**DOCKET**08-AFC-9

Application for Certification For the Palmdale Hybrid Power Project

# **Energy Commission Staff's Comments on the Presiding Member's Proposed Decision**

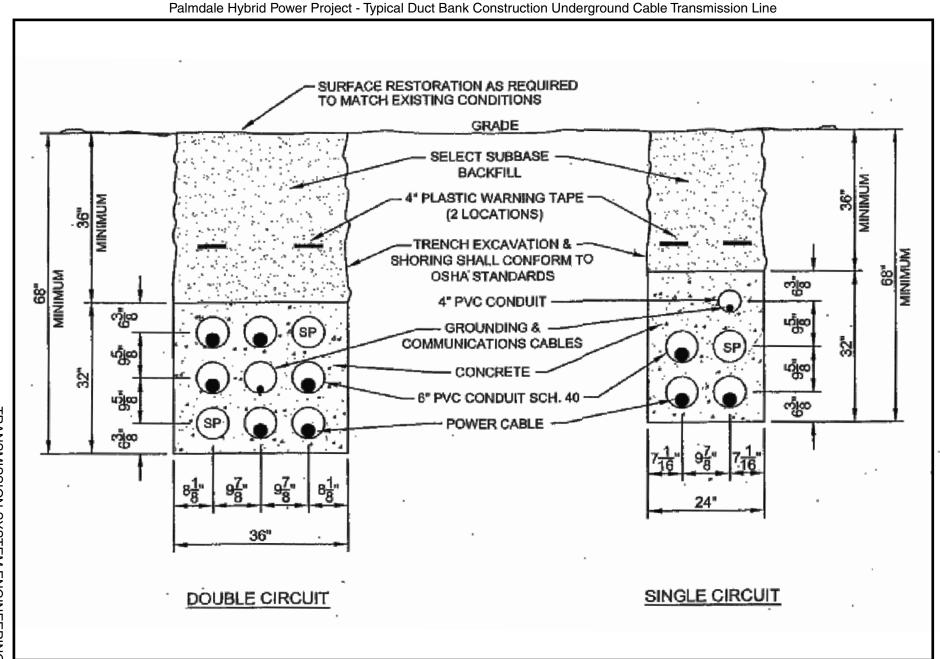
Page 5.4-4. Alternatives Appendix A – Figure 1 "Diagram of a Typical Transmission Riser Structure – Palmdale Hybrid Power Plant" should be replaced with Project Description – Figure 1 "Palmdale Hybrid Power Plant – Typical Duct Bank Construction Underground Cable Transmission Line." The discussion preceding the figure refers to the Duct Bank Underground Cable Line; however, because both figures were labeled figure 1 there was apparently some confusion and the PMPD included a diagram of a typical transmission riser structure instead. To avoid any unnecessary confusion, staff recommends replacing the figure with the correct Figure 1, attached at the end of this document.
